Department of Infrastructure, Planning and Natural Resources

ASSESSMENT REPORT

PROPOSED EXTENSION OF THE RIDGEWAY GOLD MINE

File No: S04/01474

Figure 4: Predicted Maximum Groundwater Effects (Approved Ridgeway mine on Left, Ridgeway plus Ridgeway Deeps on Right)

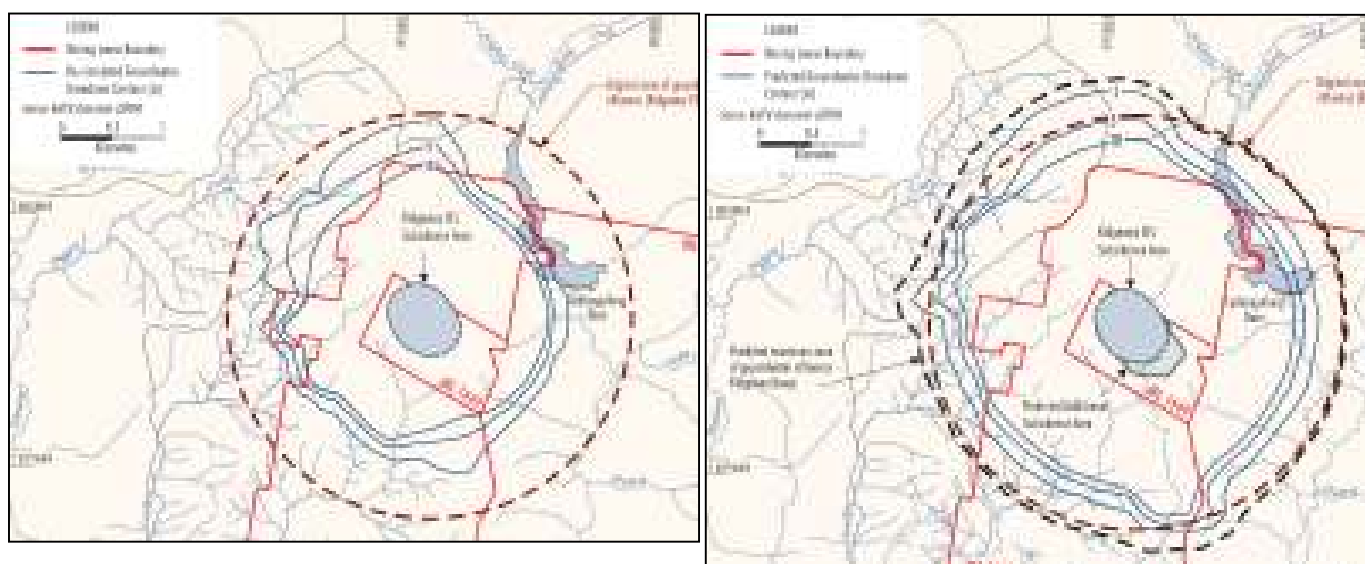
Modelling undertaken for the groundwater assessment indicates that the Ridgeway Deeps proposal would increase the drawdown (ie. lowering of the groundwater table) beyond the original zone of influence of the approved mine (see Figure 4). However, the report notes that the additional area and magnitude of drawdown is very small compared to the approved zone of influence and does not extend into an area of groundwater usage.

Based on this additional drawdown area, and assuming a 100% loss of stream baseflows within the additional area, the surface water assessment estimates that there would be the following reductions in flow (mean annual) in affected waterbodies at nominated locations downstream of the mine:
